UNITED STATES PATENT AND TRADEMARK OFFICE

APPLICATION NO.	FILING DATE	FIRST NAMED INVENTOR	ATTORNEY DOCKET NO.	CONFIRMATION NO.
10/555,723	11/07/2005	Andreas Smolarek	HEU-003USRCE	2043

Office Action Summary	Application No. 10/555,723	Applicant(s) SMOLAREK, ANDREAS	
	Examiner GHASSEM ALIE	Art Unit 3724

Fig. 1

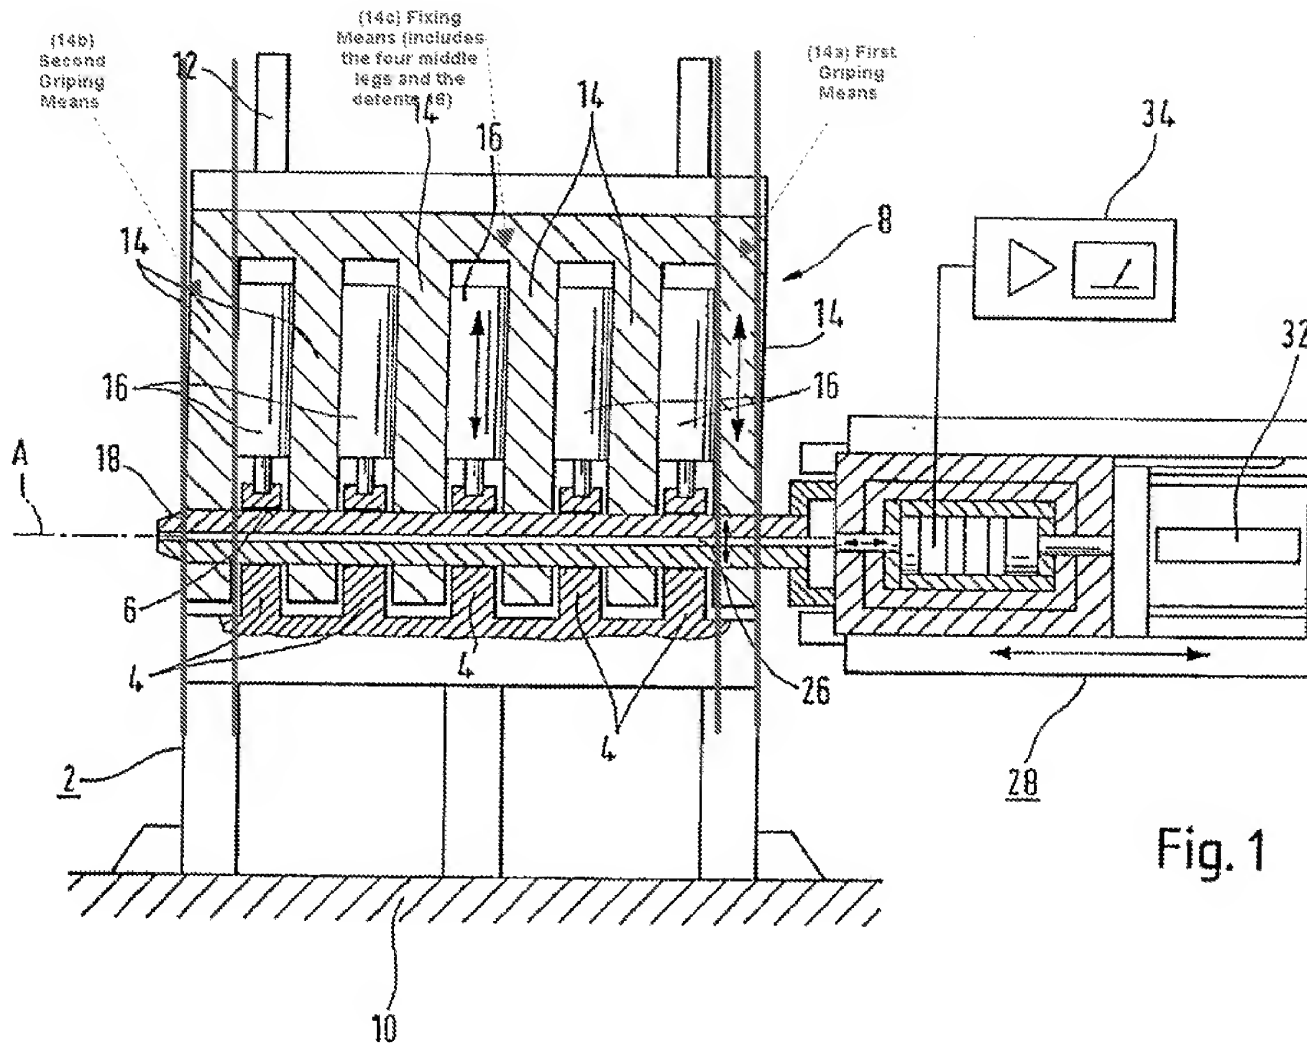
2. Claims 2-8 and 10 are rejected under 35 U.S.C. 102(e) as being anticipated by Hahnel et al, US 2004/0011842, hereafter Hahnel. With respect to claim 2, Hahnel discloses a device configured to perform breaking separation of at least one bearing cap 4 from a corresponding thrust block in a bearing assembly an engine case provided with bearing bores 6 arranged in-line (along axis A), comprising an extension mandrel (18) insertable into at least one of said bearing bores and said extension mandrel has two half-mandrels 18.2, 18.4, an expander 26 for moving said half-mandrels apart, said expander taking effect between said half-mandrels, at least two gripping means 14a, 14b. It should be noted that the gripping means are defined by two legs of the counter mount 14 that are secured to a fixing means 14c. The fixing means I defined by the horizontal bar, the four middle legs, and the detents 16 of the counter mount 14. Hahnel also teaches that each gripping means 14a, 14b including one or more protruding engagement members, at least one the one or more protruding engagement members being configured to grip at recesses 22 of one half-mandrel 18.4 corresponding to the at least one bearing cap, while the other half-mandrel is moving with respect to the gripping means. See Fig. 1 above. It should be noted that the one of the protruding engagement member is defined by at least one of the jaws of the gripping means 14a, 14b that holds or retains the mandrel at recess 22. Hahnel also teaches a fixing means 14c connected to the at least two gripping means 14a, 14b, wherein the at least two gripping means protrude from the fixing means, wherein the at least one bearing cap 4 being clampable between said corresponding half-mandrel and said fixing means, such that a unit comprising said

corresponding half-mandrel, said gripping means, said fixing means and said clamped bearing cap is supported in a freely movable manner to a limited degree, though secured against rotation, in the direction of breaking separation. It should be noted that the portion of the bearing cap 4 that is located above the top half mandrel 18.4 is clampable by the four middle legs and the detent 16 of the fixing means 14c and the top half mandrel 18.4. See Fig. 1 above.

5. Applicant's arguments filed on 02/25/2010 have been considered but they are not persuasive. Applicant asserts that even if the top plate of the clamping fixture 8 of the Hahnel reference may be interpreted as fixing means, the Hahnel reference still fails to teach that the half mandrel and the top plate to clamp the bearing cap 4. Applicant also asserts that the bearing cap is provided below the top plate and the mandrel. Firstly, claim 1 merely recites, "wherein said at least one bearing cap being clampable between said corresponding half-mandrel and said fixing means." As stated above the fixing means has middle legs and detents 16 that clamp the bearing cap 4 between the top half-mandrel 18.4 and the fixing means. Secondly, the cap 4 is located above and below the mandrel 18. Therefore, the top

portion of the bearing cap 4 above the half-mandrel 18.4 is clampable between the fixing means 14c and the half-mandrel 18.4. In addition, claim 1 does not recite how the fixing means can clamp the bearing cap. Claim 1 omits the essential feature (detents) of the fixing means for clamping the bearing cap. Therefore, the fixing means set forth in claim 1 without the essential feature (detents) does not have the capability of clamping the bearing cap. In another words, the gripping means also could be considered as clamping means for the fixing means, since the gripping means protrude from the fixing means. Claim 1 does not call for any other clamping means other than the gripping means and mandrel.

It should be noted that claim 1 does not specify the detail structure of the pincers and the detents. It is suggested that claim 1 recite the detail structure of the pincers, pins and their locations on the fixing means.
